**EXPRESS TERMS
FOR
PROPOSED BUILDING STANDARDS
OF THE
DEPARTMENT OF HOUSING AND COMMUNITY DEVELOPMENT
REGARDING PROPOSED CHANGES TO THE 2007 CALIFORNIA BUILDING CODE (CBC)
CALIFORNIA CODE OF REGULATIONS, TITLE 24, PART 2
(CHAPTER 11A HOUSING ACCESSIBILITY)**

**CHAPTER 11A
HOUSING ACCESSIBILITY**

FIGURE 11A-8J – PLATFORM AT SECONDARY EXTERIOR DOOR

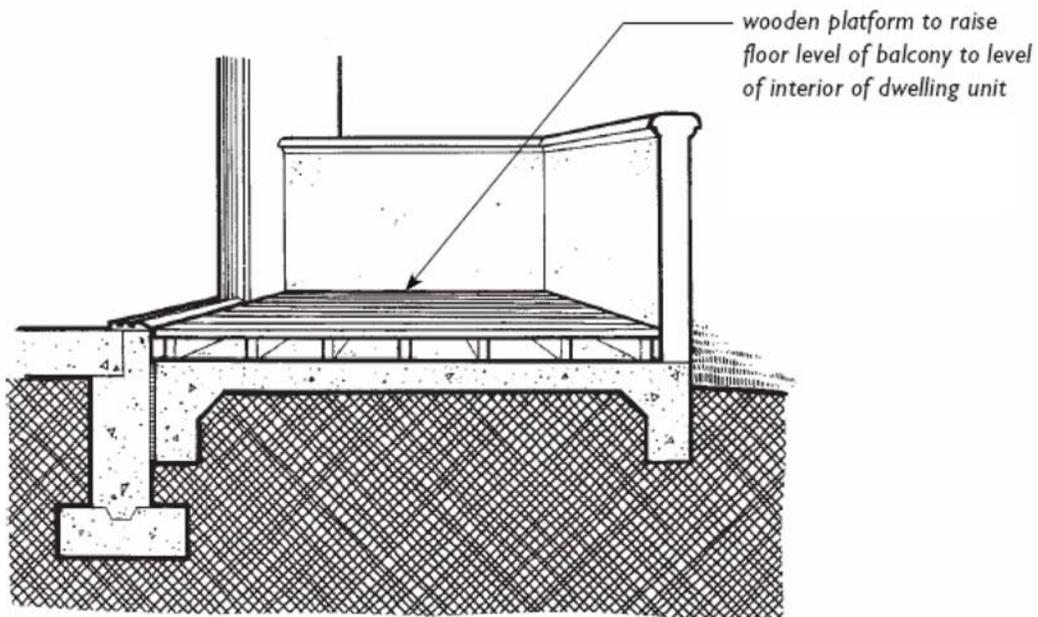
3. Secondary exterior doors onto decks, patios or balcony surfaces constructed of impervious materials (e.g., concrete, brick, flagstone) may have a maximum change in height from the interior landing of 4 inches (101.6 mm). Changes in height greater than ½ inch (12.7 mm) shall be accomplished by means of a ramp complying with Section 1114A or by means of a platform constructed to the level of the floor as illustrated in Figure 11A-8J.

FIGURE 11A-8K – RAMP AT SECONDARY EXTERIOR DOOR

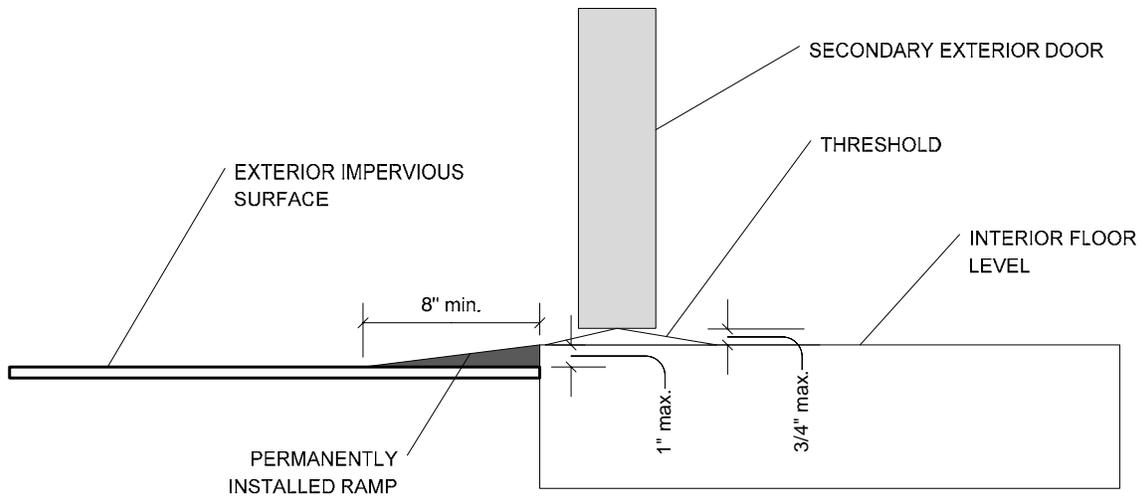
4. Secondary exterior doors onto decks, patios or balcony surfaces constructed of impervious materials (e.g. concrete, brick, flagstone) may have a maximum change in height from the interior landing of 1 inch (25.4 mm), provided a ramp with a maximum slope of 1:8 is permanently installed. Handrails at exterior door ramps shall comply with Section 1114A.6. (See Figure 11A-8K.)

Exception: Ramps at exterior door landings less than 6 inches (152 mm) rise or less than 72 inches (1829 mm) in length shall not require handrails. (See Section 1114A.6.)

FIGURE 11A-9L – SHOWER WITH WATER CLOSET

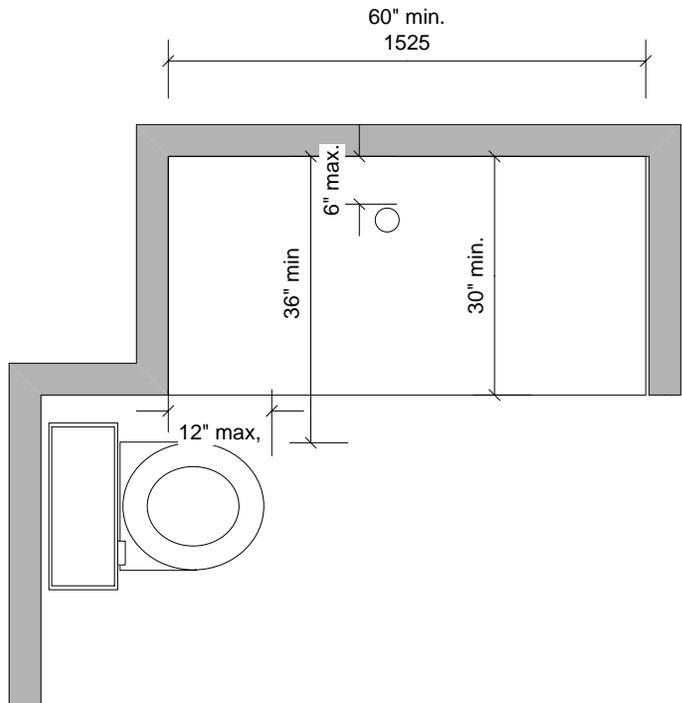
1.2 The shower stall shall measure at least 30 inches deep by 60 inches wide (762 mm by 1524 mm) with an entrance opening of at least 60 inches (1524 mm). A water closet may project a maximum of 12 inches (305 mm) into the opening provided that a minimum of 36 inches (914 mm) clear space is maintained between the water closet and the shower wall as illustrated in Figure 11A-9L or;

FIGURE 11A-9M – WING WALL OR CABINET AT WATER CLOSET

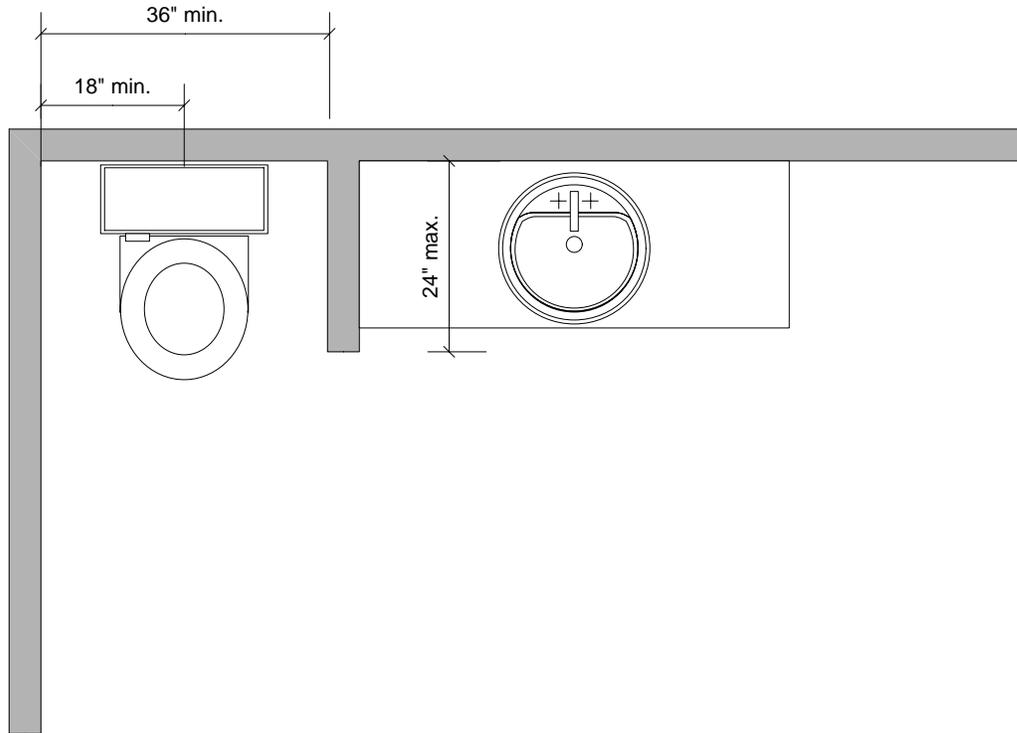
Exception: In covered multifamily dwelling units, the water closet may be located in a space 48 inches (1219 mm) in clear width with 36 inches (914 mm) of clear space provided in front of the water closet. Wing walls, privacy walls and lavatory cabinets located adjacent to the water closet may encroach a maximum of 24 inches (610 mm) into the clear floor space required by this section. The compartmentalized area formed between wing wall, privacy wall, lavatory cabinet and the opposite wall shall maintain a minimum clearance of 36 inches (914 mm). (See Figure 11A-9M.)
